## OIL FILTER / ELECTRA GLIDE, SPORTSTER

Starting with production Electra Glides and Sportster XLH models on June 9, 1969, a vent hole has been added to the filter cup as shown in the illustration.

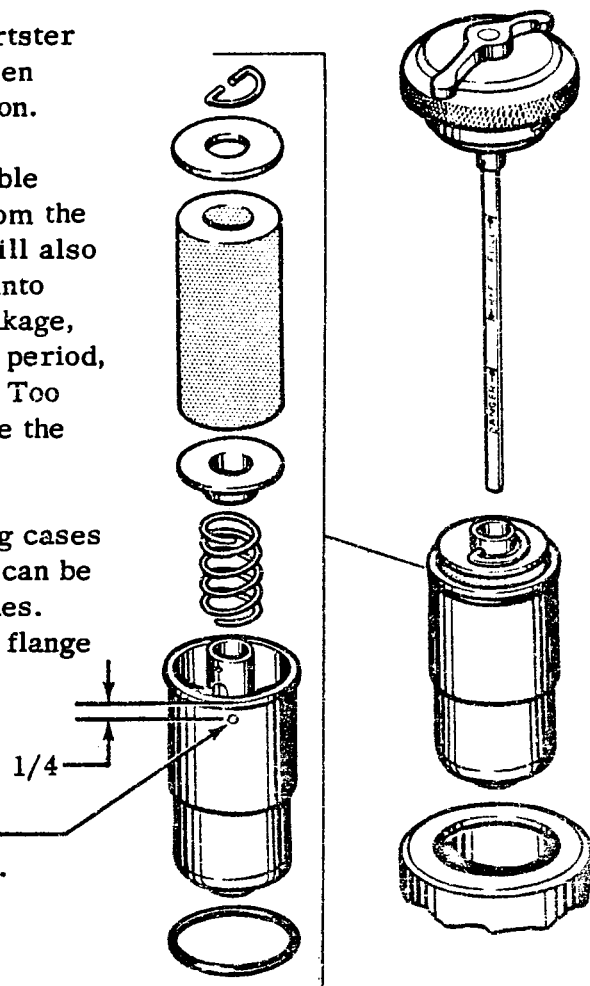
The purpose of this hole is to relieve any possible pressure buildup in the tank which forces oil from the tank when the cap is removed. The vent hole will also prevent possible siphoning of oil from the tank into the engine after the engine is stopped. Such leakage, while the engine is not operated for an extended period, could find its way into the primary chain case. Too high an oil level in the chain case would saturate the clutch linings.

To prevent this possibility or to correct existing cases of tank pressure or siphoning, a 1/16 dia. hole can be drilled in the oil filter cup on earlier motorcycles. The hole should be drilled 1/4 in. below the top flange as shown in the illustration.

Drill vent hole (1/16 dia. drill)  
thru side of cup, 1/4 in. below flange.
